Office Action Summary	Application No. 10/591,320	Applicant(s) TSUBOI ET AL.	
	Examiner RYAN DODD	Art Unit 3655

DETAILED ACTION

This is the fourth office action on the merits for Application Serial Number 10591320, which is a National Stage/371 of PCT/JP04/02737.

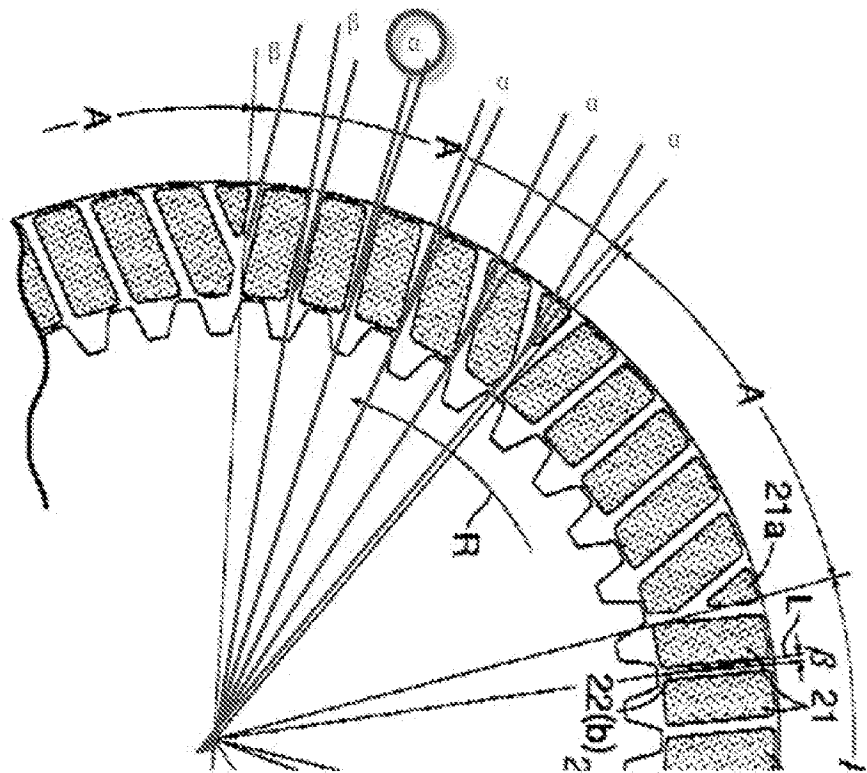
As to **claims 4-6**, the limitation: “wherein the discharge angle (β) is equal to the inflow angle (α)”, may be interpreted to mean that every angle (β), formed by a radial line (L) of the friction plate passing through and inner end of the discharge oil channel itself (claim 1, lines 11-12), of which there are many (see figure below), is equal to every angle (α), of which there are multiple. Although there are particular angles (β) that may be equal to particular angles (α), the interpretation herein presented is not enabled in such a way as to enable one skilled in the art to make the invention, because every angle (β) is not equal to every angle (α).

Similarly, As to **claims 7-9**, the limitation: “wherein the discharge angle (β) is less than the inflow angle (α)”, may be interpreted to mean that every angle (β), formed by a radial line (L) of the friction plate passing through and inner end of the discharge oil channel itself (claim 1, lines 11-12), of which there are many (see figure below), is less than every angle (α), of which there are multiple (see figure below). Although there are particular angles (β) that may be less than particular angles (α), the interpretation herein presented is not enabled in such a way as to enable one skilled in the art to make the invention, because every angle (β) is not less than every angle (α).

As will be appreciated by Applicant, for instance, in reference to Applicant's Fig. 2, what is defined as a discharge angle actually reduces in value as the channels are counted from left to right in any given section. The middle channel potentially has a zero angle value and therefore could not be classified as either an inflow or a discharge angle. Even still, there are at least two discharge channels, each having different discharge angles, and two inflow channels, each having different inflow angles. Therefore regarding **claim 4**, to say that *the* discharge angle is equal to *the* inflow angle, is incorrect and indefinite.

Even regarding Applicant's 2nd and 3rd embodiments of Figs. 3 and 4, there exists at least either multiple discharge channels or multiple inflow channels and so it is likewise incorrect and indefinite to refer to either *the* discharge angle or *the* inflow angle. Therefore **claims 5-9** are likewise indefinite.

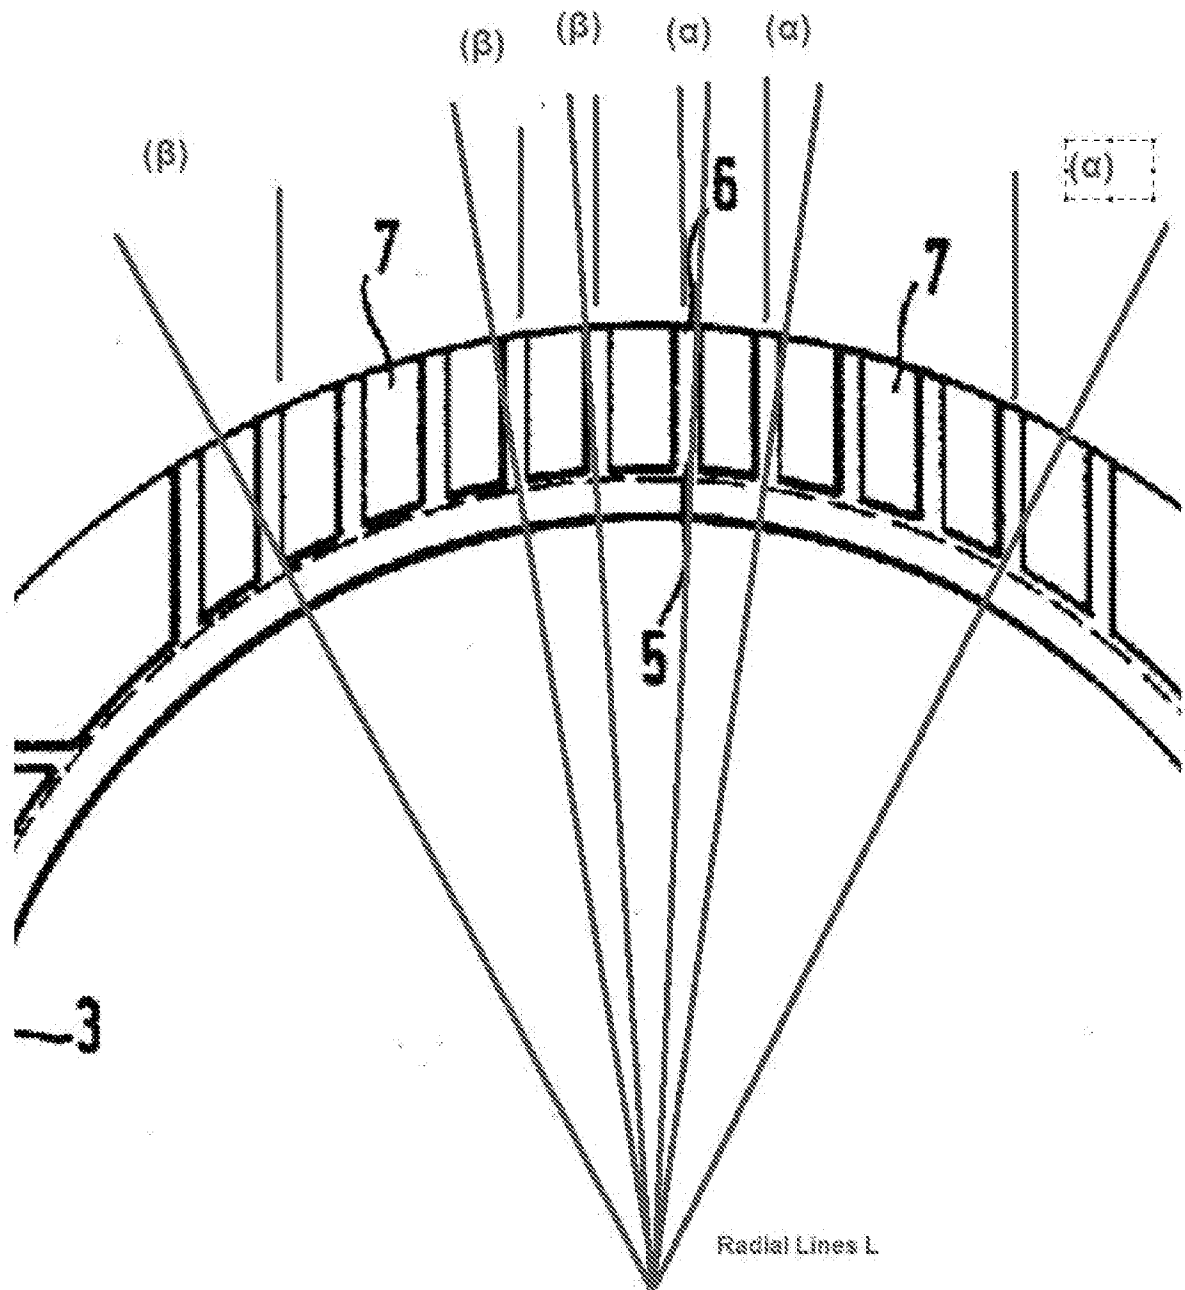
peripheral side of the friction plate due to a screw pump action that occurs when the friction plate rotates relative to the clutch plate (see Fig. 2, and figure below), and

- the plurality of oil channels further include a plurality of inflow oil channels having an inflow angle (α) relative to the radial line (L) of the friction plate and which are configured to draw oil in from the outer peripheral side to the inner peripheral side of the friction plate due to the screw pump action that occurs when the friction plate rotates relative to the clutch plate (see Fig. 2 and figure below), and
- wherein the discharge angle (β) inclines rearward relative to the radial line (L) and the inflow angle (α) inclines forward relative to the radial line (L) (see Fig. 2, and figure below).

Because the inflow and outflow channels of Bauer '282 are arranged in a similar fashion to the present invention as claimed it can be said that the channels of Bauer

'282 will perform in the same manner as the present invention (causing the inflow and discharge of oil). It can also be said that core plates of Bauer '282 and the clutch plate for which it is made to rotate relative to will exhibit a "screw pump action", if that is what applicant's claimed invention will do, because the channels of Bauer '282 are formed in the same way that of the present application.

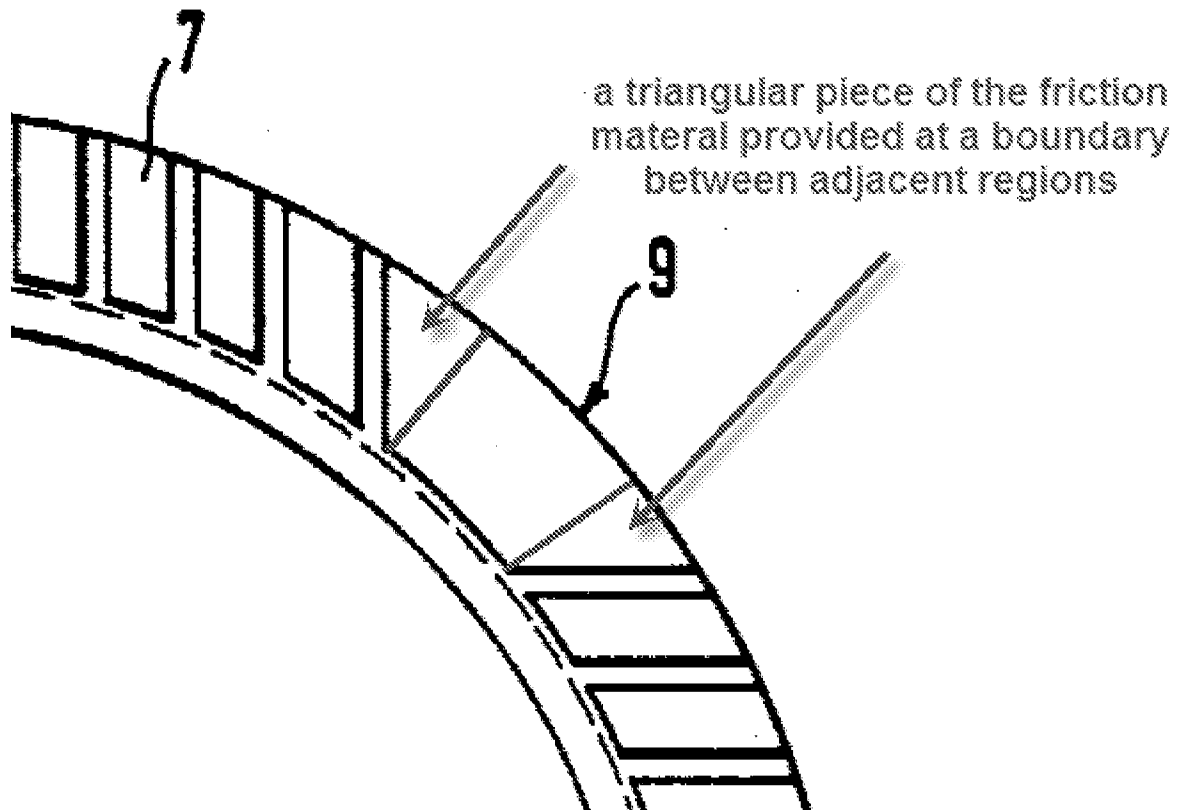
As to **claim 2**, Bauer '282 discloses that the friction plate is divided into a plurality of regions (A) arranged in the peripheral direction, each region including an equal number of discharge and inflow oil channels (for instance in Fig.3 Bauer '282 implies 4 regions).

As to claim 3, Bauer '282 discloses a triangular piece of the friction material that is provided at a boundary defined between adjacent regions (see figure below).

As to **claims 4-9**, as best understood, at least one discharge angle (β) of Bauer '282 is equal to at least one inflow angle (α), and at least one discharge angle is less than at least one inflow angle, as measured from a radial line L (See Fig.2, and figure above).
